New High School in Jerrabomberra (SSD-24461956)
Response to request for additional information

RE: New High School in Jerrabomberra SSD RFI

PROJECT: MONARO CLUSTER - JERRABOMBERRA HIGH SCHOOL
JOB NO.: 200095

Figure 1 – Louvred openings to door sidelights at the entries to the Learning Commons

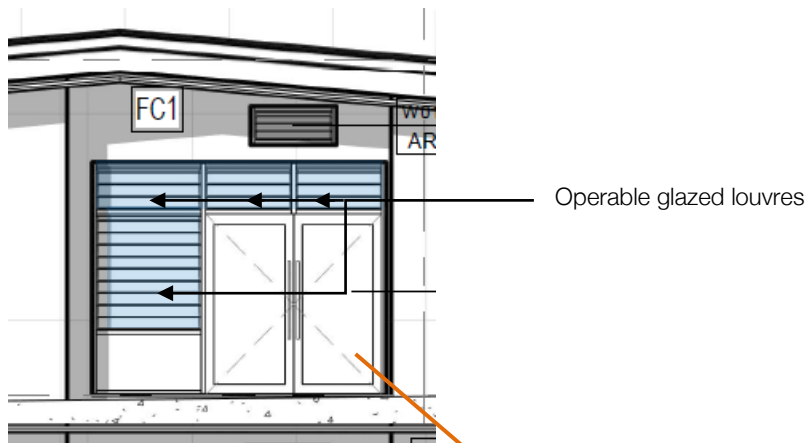
- b. Additional opportunities to promote cross-ventilation are to be pursued. Consider adding northern openings to the learning spaces adjoining the student entry from Enviroa Drive (to the north) and to learning spaces adjoining the central open COLA/ covered walkway.*

Louvred openings have been incorporated in the highlight and sidelights to the doors at the northern and southern end of the two learning hubs in Block A, at both levels of the building. During normal operating hours the doors would also be fixed open adding to the area of opening for natural ventilation. Outside air is drawn from the open COLAs between the Hubs facilitating cross ventilation to the Learning Commons and throughout the learning Hub. As described in our response to item 2a, the cross ventilation of the Learning Hubs is provided through wide sliding glazed partitions to the external walls at the ground level and independently operated high level and lower level louvred external openings at the level above ground. The concept of the Hubs is that they are a contemporary learning environment and a departure from the traditional 'cellular' classroom. The Hubs function as a series of flexible connected spaces fostering collaboration between students and staff. Generous operable partitions and openings incorporated within the internal partitions provide that connectivity and promote cross ventilation throughout the hub. Ceiling fans supplement the cross ventilation provided by the openings and a 'traffic light' operating system for the mixed mode mechanical system allows for optimum user control over their environment without the reliance on air conditioning.
